## STAFF RECOMMENDATION
**1438 Roberts Avenue**
**December 20, 2017**

**Application:** New construction – addition; Partial demolition
**District:** Eastwood Neighborhood Conservation Zoning Overlay
**Council District:** 06
**Map and Parcel Number:** 08302010700
**Applicant:** Kaitlyn Smous, nine12 design
**Project Lead:** Melissa Sajid, melissa.sajid@nashville.gov

| **Description of Project:** Application is to construct a rear addition, to demolish an existing rear addition and to replace existing siding and front porch posts on the historic house.<br><br>**Recommendation Summary:** Staff recommends approval with the following conditions:<br><br>**1.** Staff approve the final details, dimensions and materials of the roof color, front porch posts, side porch floor and steps, rear porch steps, and doors prior to purchase and installation; and<br>**2.** The HVAC shall be located behind the house or on either side, beyond the mid-point of the house if relocated.<br><br>With these conditions, staff finds that the project meets Section II.B of the *Eastwood Neighborhood Conservation District: Handbook and Design Guidelines*. | **Attachments**<br>**A:** Photographs<br>**B:** Site Plan

Figure 3 (left) shows the enclosed rear porch that is to be demolished. Figure 4 (right) is the 1957 Sanborn map.

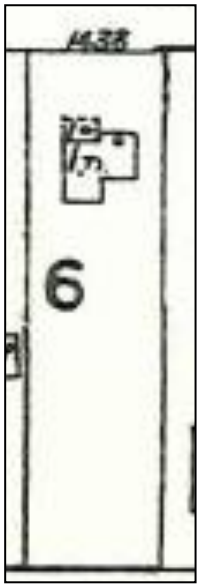
The applicant proposes to demolish an existing rear addition (Figure 3). A covered porch was added to the left side of the rear façade between 1957 and 1969 (Figures 4 and 5). The covered porch was later enclosed, and a single-story rear addition with a shed roof was added sometime after 1969 (Figures 5 and 6). Staff finds that the addition's date of construction, location at the rear of the house, roof form, materials, and design do not contribute to the historic character of 1438 Roberts Avenue or to the Eastwood Neighborhood Conservation Zoning Overlay; therefore, demolition is appropriate.

Staff recommends approval of the request to remove the rear addition, to replace the existing siding, and to replace the front porch posts, finding that these alterations meet Section III.B.2 for appropriate demolition and do not meet Section III.B.1 for inappropriate demolition.

Site Plan

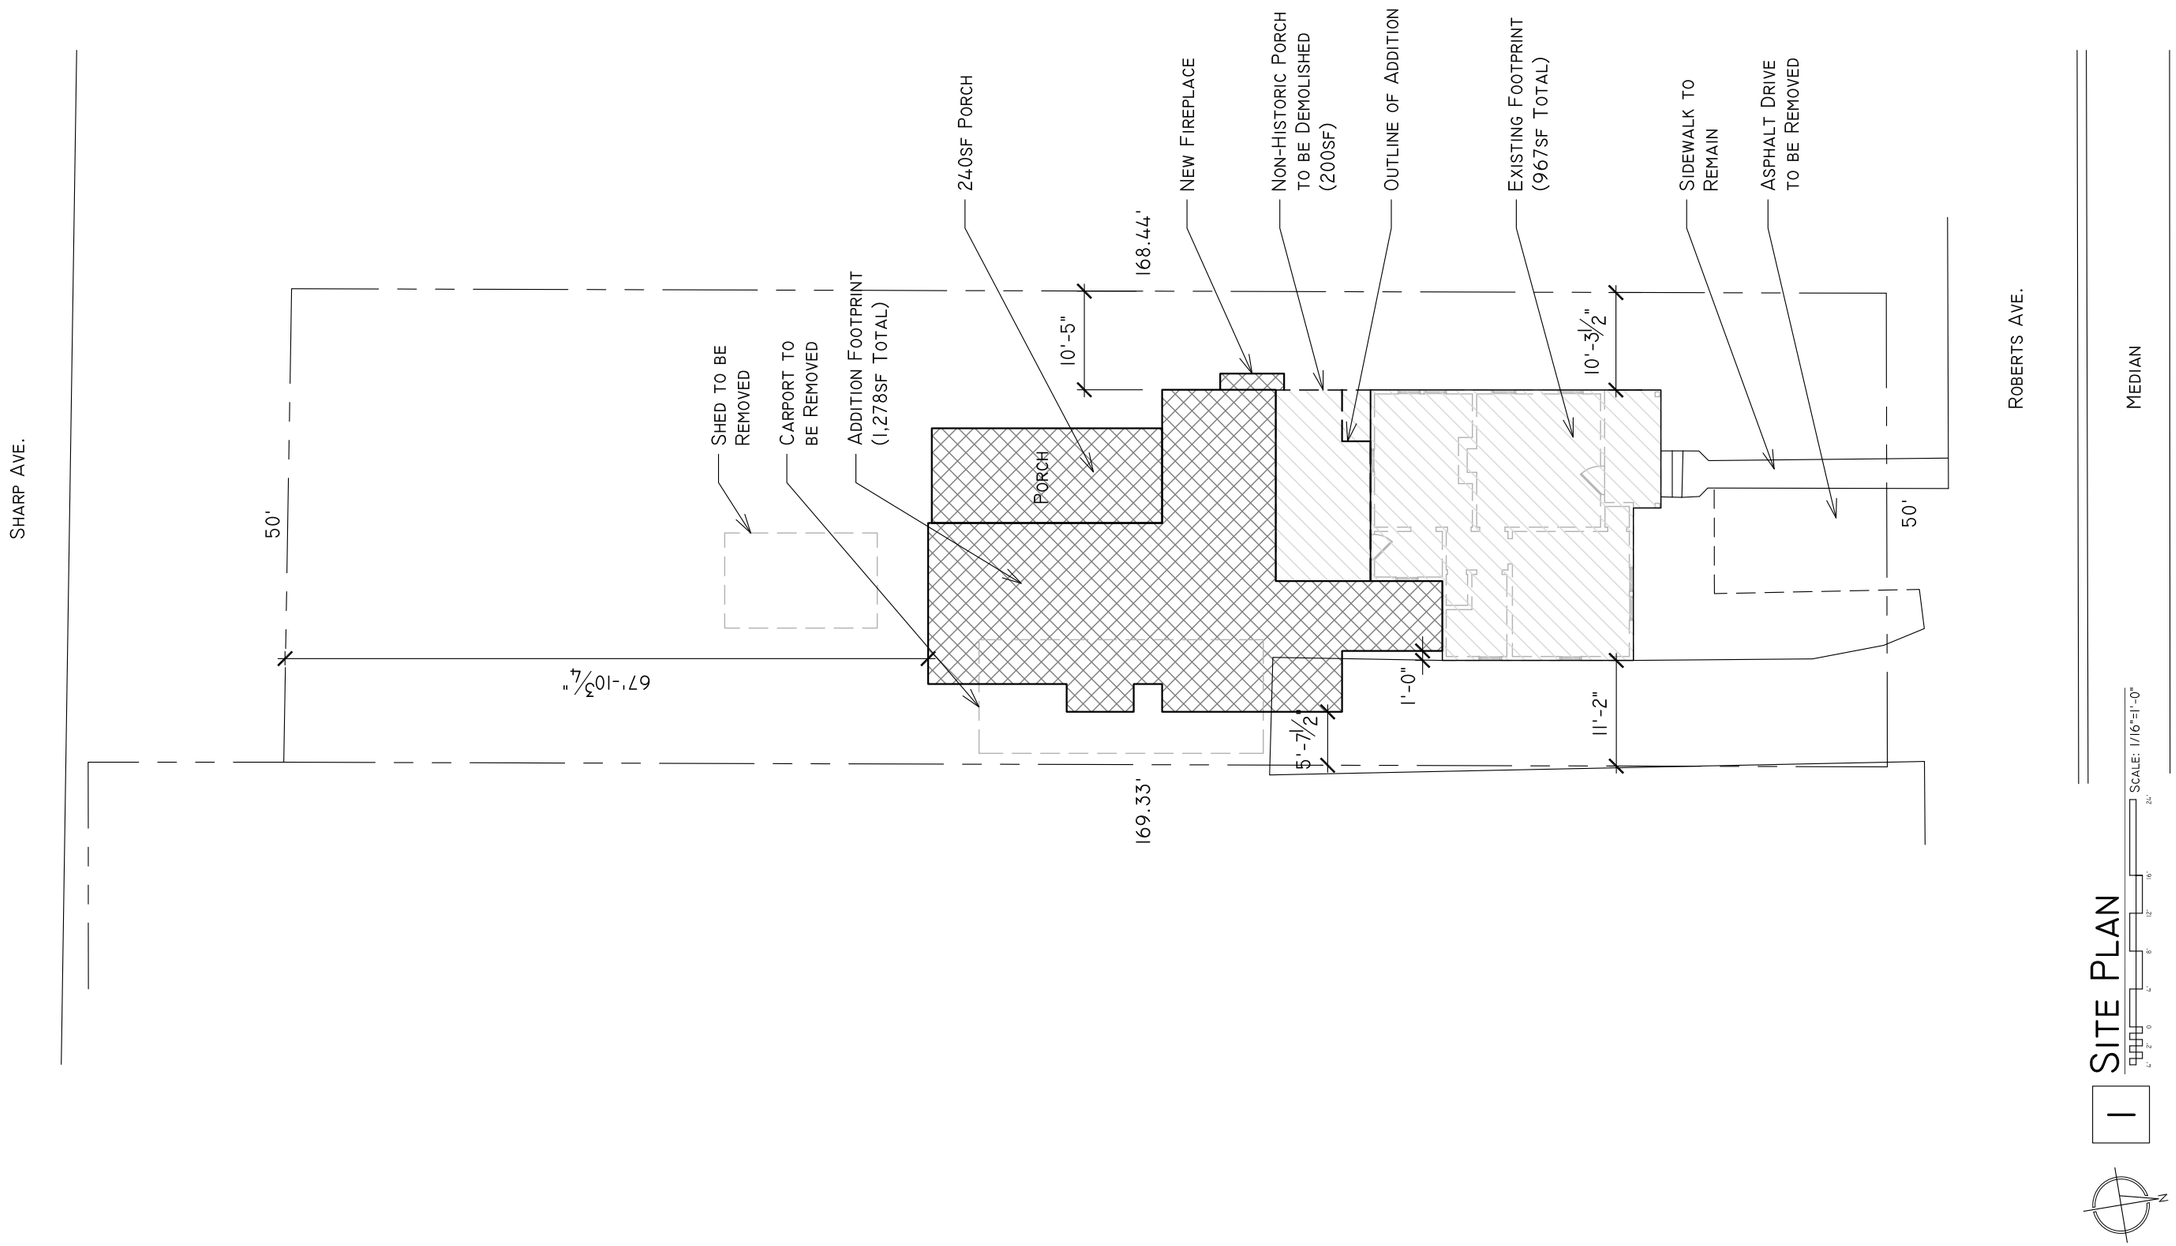
Setback & Rhythm of Spacing: The addition meets all base zoning setbacks. It will be approximately five feet, seven inches (5'-7") from the left side property line, ten feet, five

inches (10'-5") from the right side property line, and sixty-seven feet, ten inches (67'-10") from the rear property line.

Appurtenances & Utilities: The plan indicates that the existing front asphalt drive shall be removed from the center of the lot, which staff finds appropriate. The existing driveway from the curb cut to the left of the house will continue to serve the property. The subject property backs up to Sharp Avenue and does not have an existing curb cut from that street. The location of the HVAC and other utilities was also not noted. Staff asks that the HVAC be located on the rear façade, or on a side façade beyond the midpoint of the house. The project meets section II.B.1. i.

**1.** Staff approve the final details, dimensions and materials of the roof color, front porch posts, side porch floor and steps, rear porch steps, and doors prior to purchase and installation; and
**2.** The HVAC shall be located behind the house or on either side, beyond the mid-point of the house if relocated.

Elevations

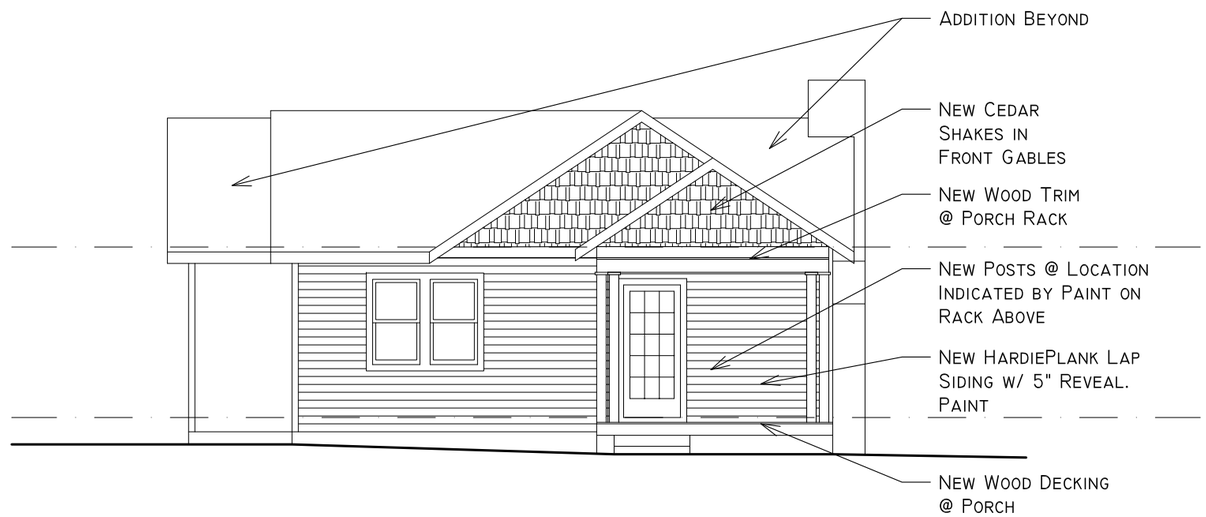
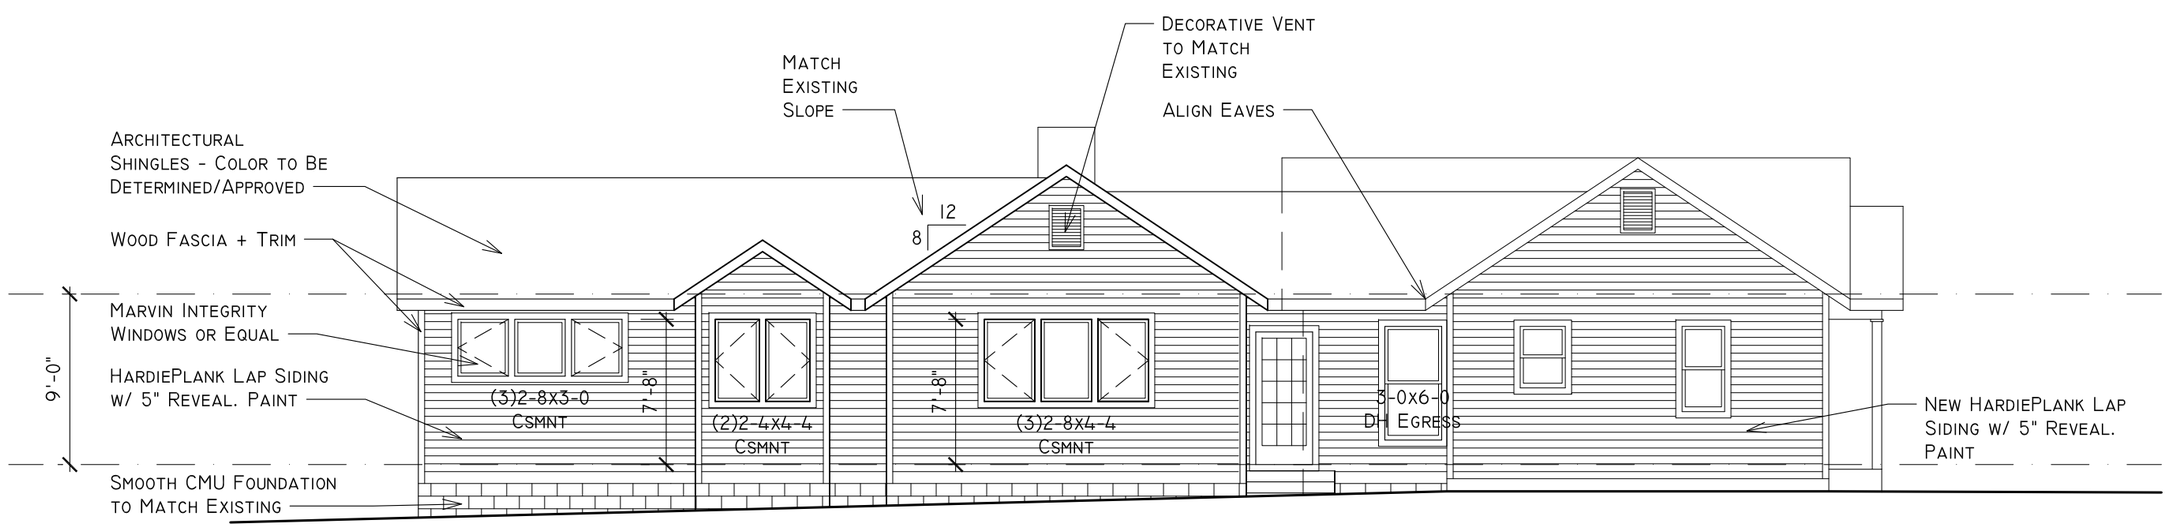
Height & Scale: The plan proposes a single-story rear addition. The majority of the addition is two feet (2') shorter than the historic house; however, the peak of the tallest side gable is six inches (6") shorter than the historic house. The addition extends five feet, six inches (5'-6") wider than the house on the left side and includes a new chimney on the right side that is two feet (2') wider than the house. An addition that is wider than the historic house is appropriate in this case as the primary massing of the house is relatively narrow at just twenty-eight feet (28') and the house is shifted to the right of the lot. In addition, the portion of the addition that extends wider is six inches (6") shorter than the historic house and incorporates a side gabled roof form that helps to minimize the impact of the wider addition as seen from the street.

Roof form: The addition is cross-gabled with a primary pitch of 8:12, which complements the roof form of the historic house. The project meets section II.B.1.e.

Proportion and Rhythm of Openings**:** No changes to the window and door openings on the existing house were indicated on the plans. The windows on the proposed addition are all generally twice as tall as they are wide, thereby meeting the historic proportions of openings. There are no large expanses of wall space without a window or door opening. Staff finds the project's proportion and rhythm of openings to meet Section II.B.1.g.

Elevations

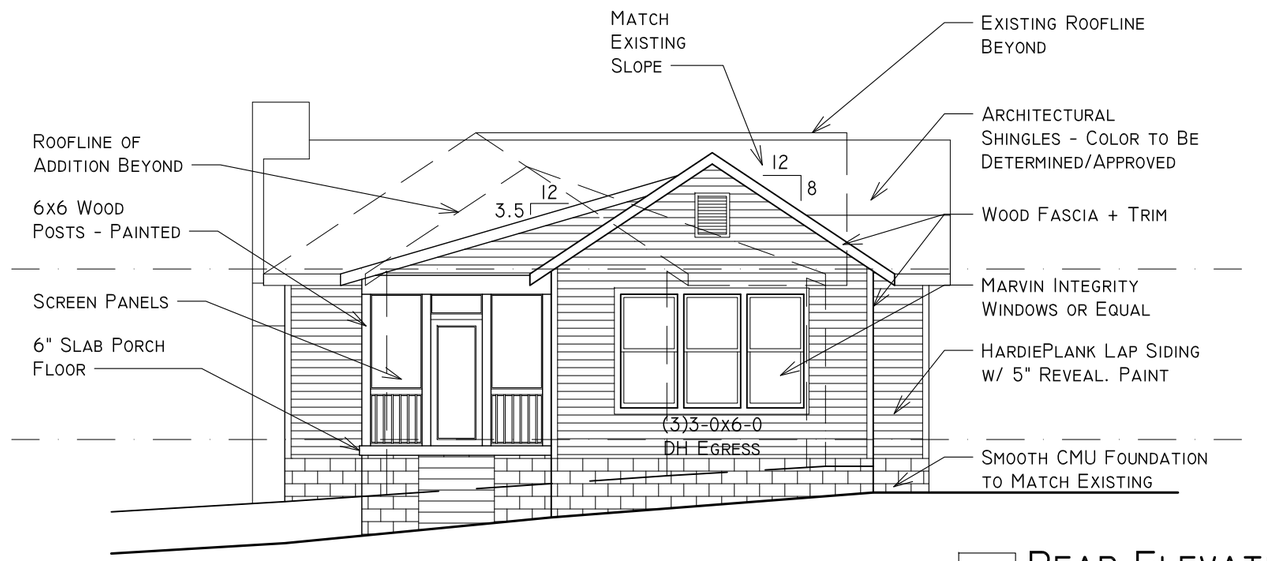
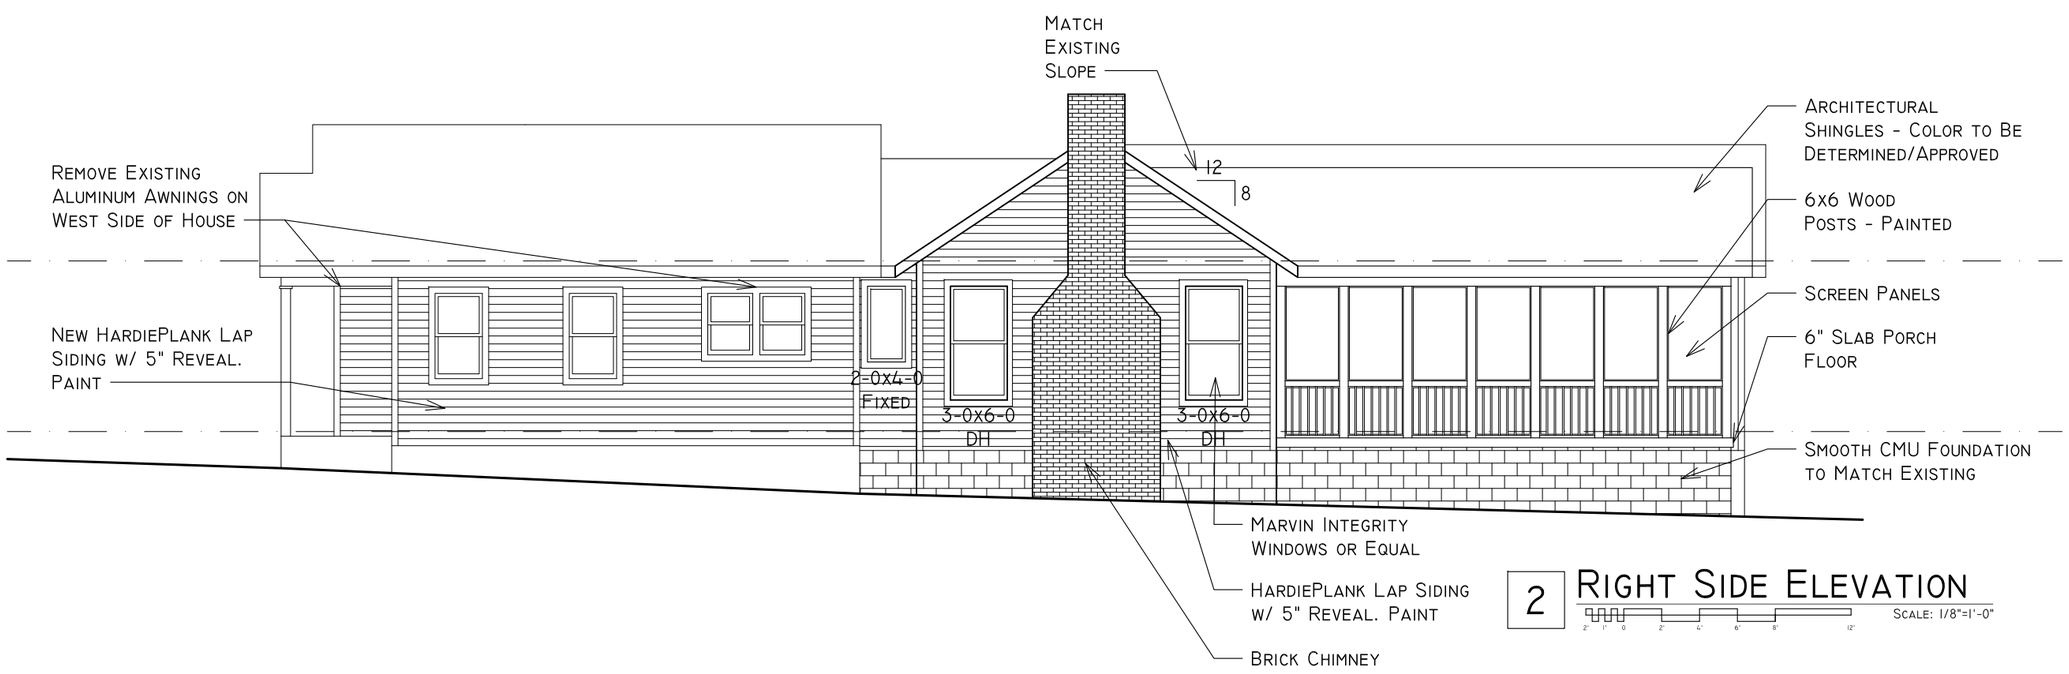
Location & Removability: The addition is located at the rear of the existing building, which is in accordance with the design guidelines. The addition sets in one foot (1') from the left rear corner and approximately five feet, four inches (5'-4") from the right rear corner, which is appropriate for a single-story addition. The addition's inset, separate roof form, and lower height help to distinguish it from the historic house and read as an addition to the house. At the same time, its scale, materials, roof form, and fenestration pattern are all compatible with the historic character of the existing house. The addition is designed so that if the addition were to be removed in the future, the historic character of the house would still be intact.
